16/04228/FUL OBJECTION: further comment

Our previously lodged objection remains in place on the basis of the earlier documented reasons, the following further comments are also lodged.

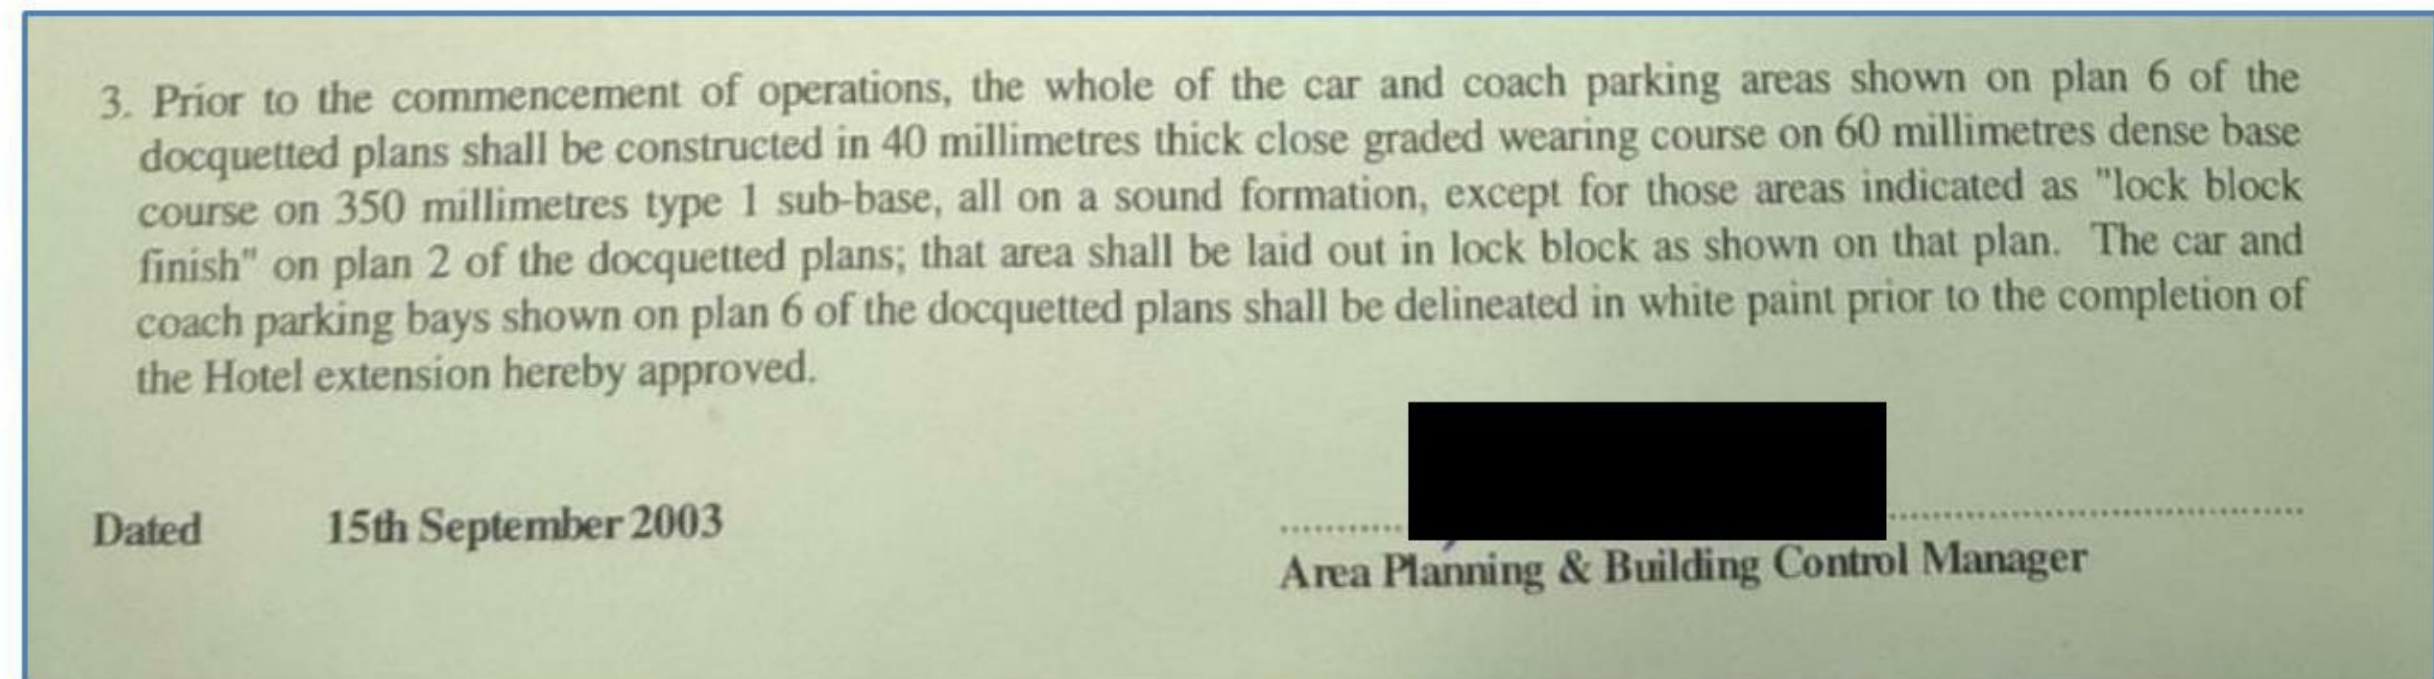
b) In relation to the current fitness and operation of the rear car park, deficiencies are exacerbated because important conditions attached to the aforementioned approval 03/00028/FULBS, granted in 2003, appear outstanding. These conditions, stipulating proper setting-out and surfacing of the hotel car park have, to date, not been carried out by the applicant nor, presumably, checked by the Council or enforced. The conditions are intended to formalise parking arrangements to the rear of the hotel including bitmac surfacing, paint marking of all parking bays and installation of essential surface run-off drainage. It is unlawful that this substantial work has not been undertaken and a clear demonstration of the Council's failing to carry out due oversight, let alone ensure competent design.

Serious concerns are raised over the likelihood car/coach parking arrangements will not be properly implemented should the current proposals receive approval. An extract from the decision notice is shown below:
